SUBJECT: Pilgrim Nuclear Power Station's Notification of Full Compliance with
Order EA-12-051, Order Modifying Licenses with Regard to
Requirements for Reliable Spent Fuel Pool Instrumentation

Pilgrim Nuclear Power Station
Docket No. 50-293
License No. DPR-35

PNPS Letter 2.15.051

Attachment 1 to
Pilgrim Letter 2.15.051
Compliance Bases for Order EA-12-051

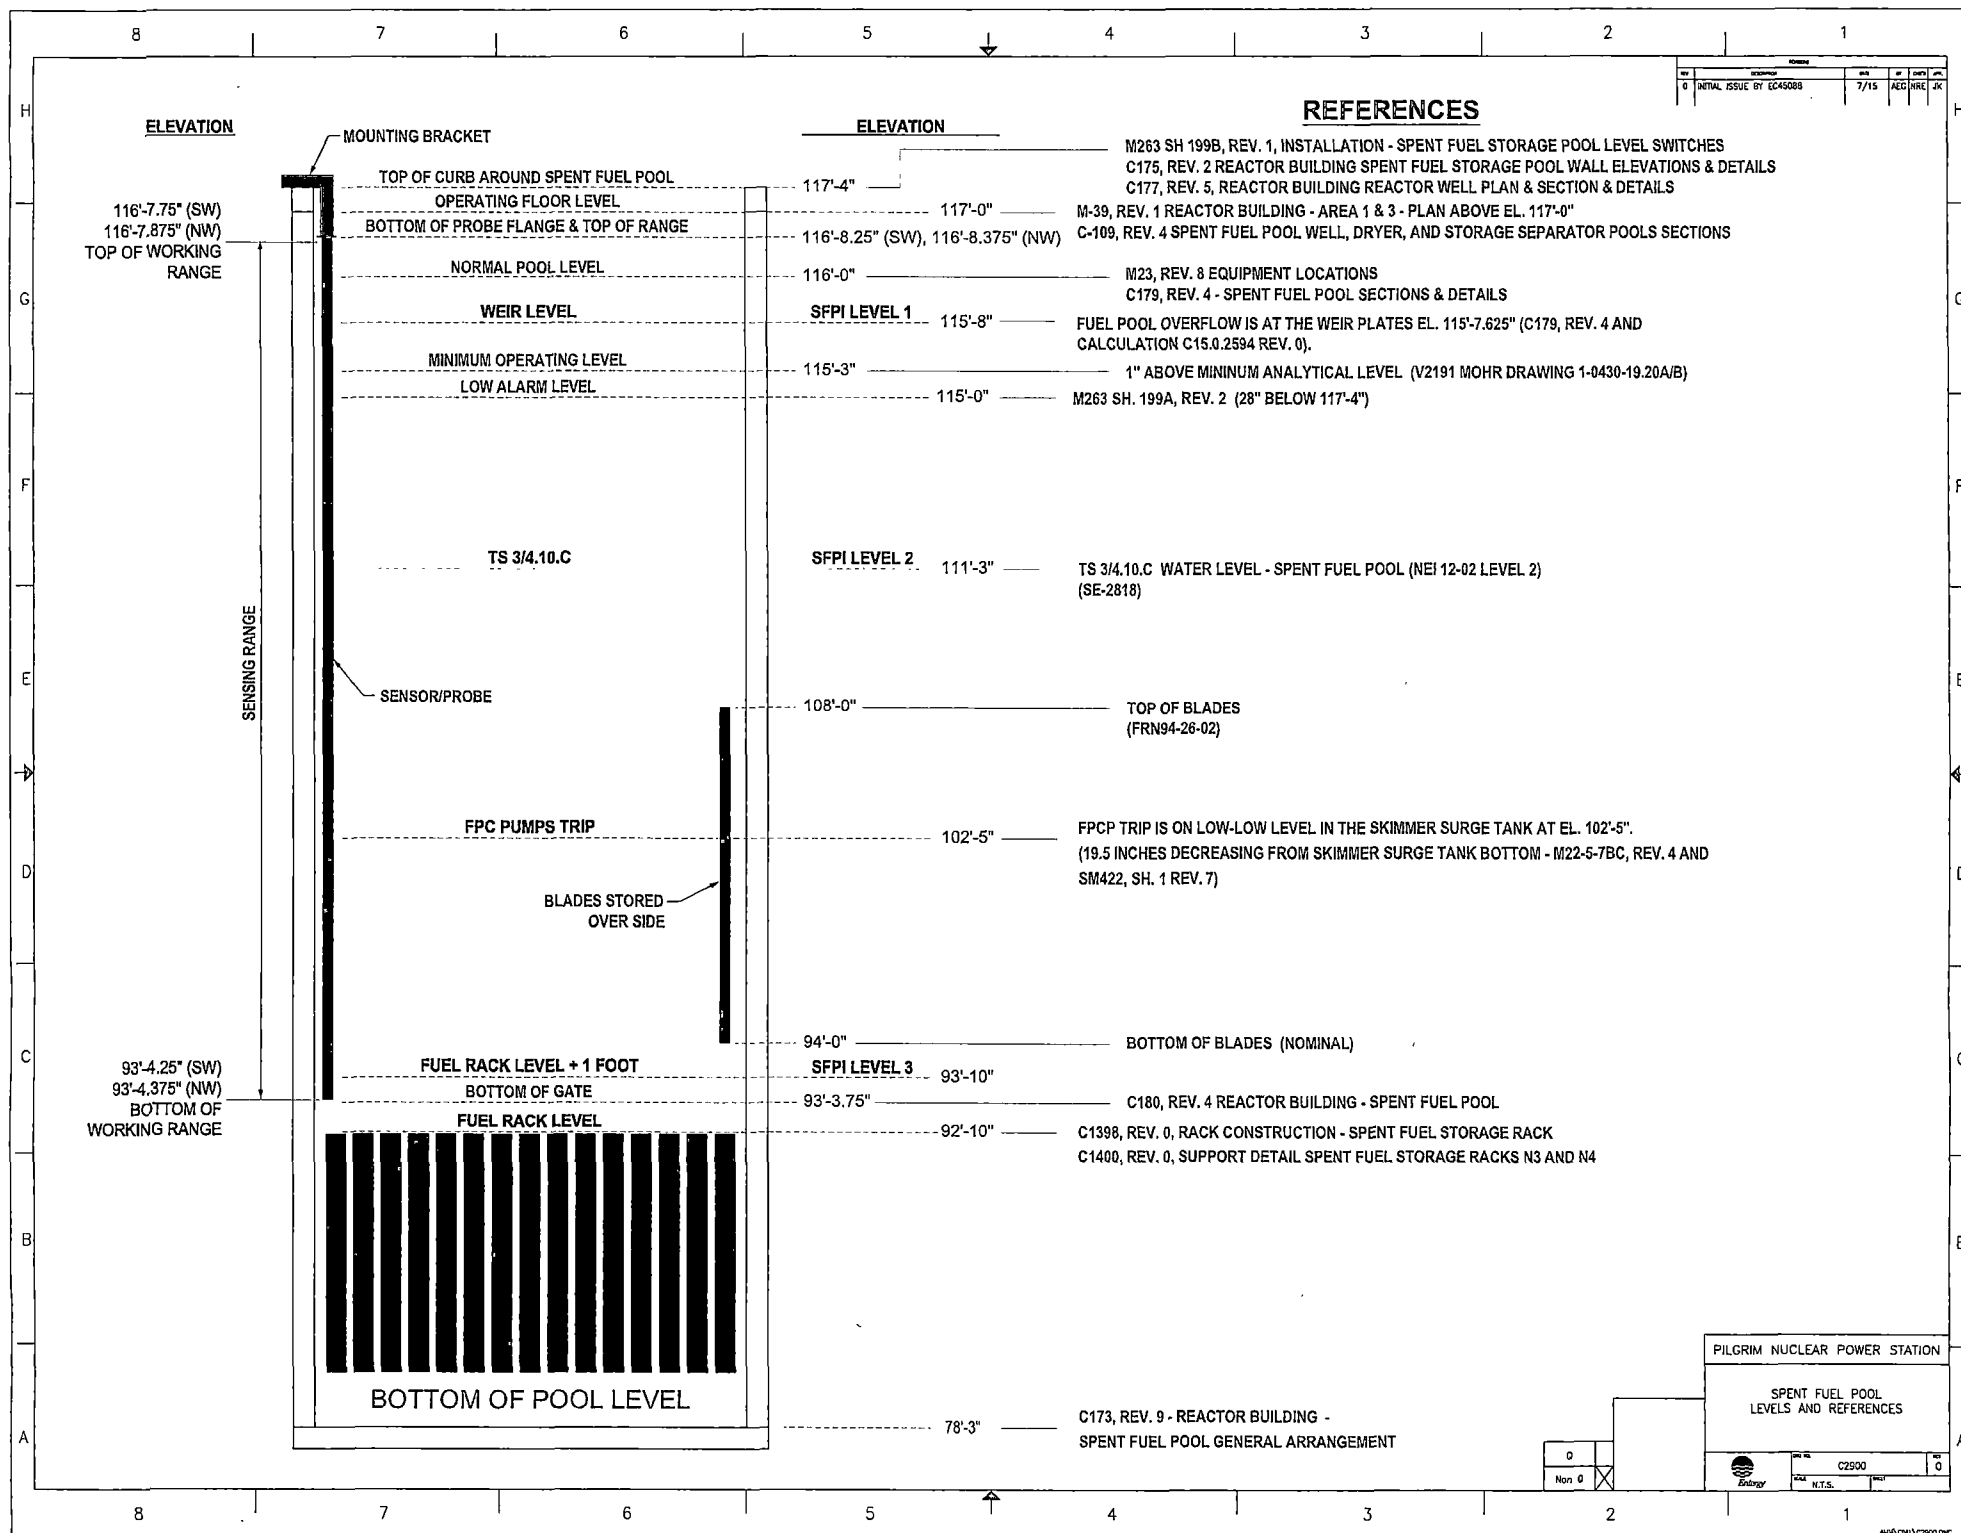
Audit item no.	Original Document Reference	Item	Status
D.		Order 051-SFPI ISE RAIs	
1-D	SFPLI RAI 1	Provide plan view of SFP area showing SFP inside dimensions, planned locations/placement of primary and backup SFP level sensor, and proposed routing of cables that will extend from these sensors toward location of display device.	<p>CLOSED</p> <p>Attachment 4 provides a plan view of the proposed locations of the probes.</p> <p>The SFPI conduit is routed to exit the Refuel Floor, elevation 117 ft. as soon as possible to minimize the possibility of physical damage to both loops from damage due to potential debris during a beyond design basis external event. The Channel A conduit will be installed on or very close to the floor at the west wall until it exits the refueling floor. The Channel B conduit will be installed at a higher elevation above the refueling floor in the southeast corner until it exits the refueling floor.</p> <p>NRC Staff performed tour of site on October 2014 and verified there is adequate separation between the cables and the cables are protected against internal missiles.</p> <p>See Attachment 5 to this letter for a drawing showing the layout.</p>
